MEMORANDUM

SUBJECT: Site Visit Report
Shadow Lake Dam (State ID No. 81.02), Glover, Vermont
SIGNIFICANT Hazard Potential

Photo 3: The gate plate extending into the 36 inch concrete pipe waterway opening. From the invert of the pipe to the bottom of the plate was measured to be approximately 21 inches. From the bottom of the plate to the crown of the pipe was measured to be approximately 15 inches.

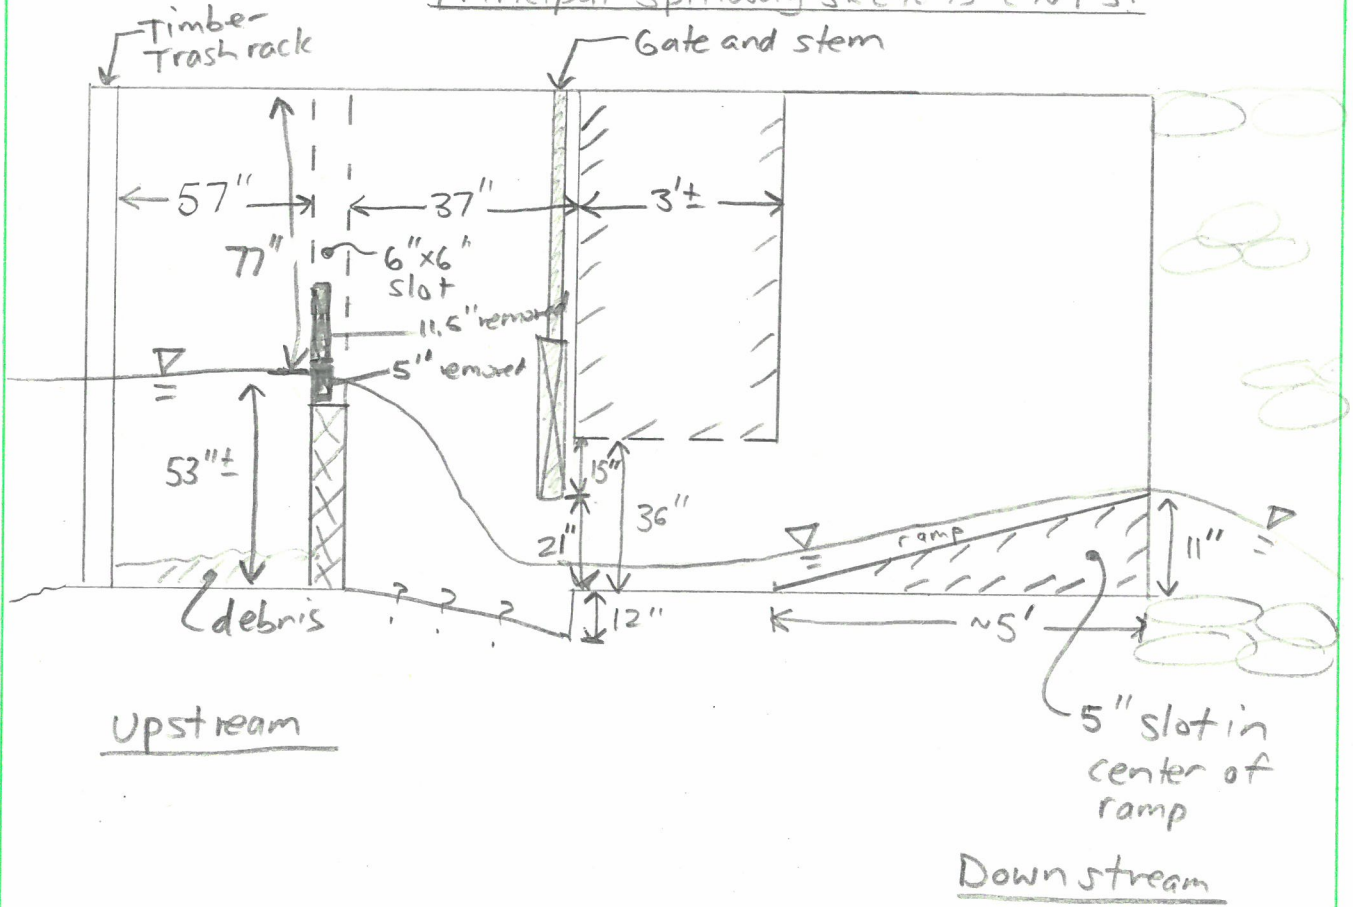
- The face mounted metal slide gate is located approximately 37 inches downstream of the stoplogs. The gate sides appeared to be properly situated in the guide channels. The gate was test operated to nearly fully closed and back to its typically maximum opening position, which was measured to be approximately 21 inches above the invert of the 36-inch diameter concrete discharge pipe (or 15 inches protruding into the opening) downstream of gate. The gate operated smoothly through this range and did not appear to have any areas of binding. The reason for the gate not opening clear of the 36-inch pipe were investigated. The top of the rising stem did not appear to have interference and the gate itself did not appear to reach a stop point. It was surmised that perhaps the bottom end of the threaded stem is reached at its current maximum opening position and that is the reason it cannot be opened clear. While this could not be visually confirmed as it is in the internal workings of the gate, the theory appears credible. Jack Sumberg reported that the configuration of the gate has been unchanged since his involvement in dam operations in 2012.
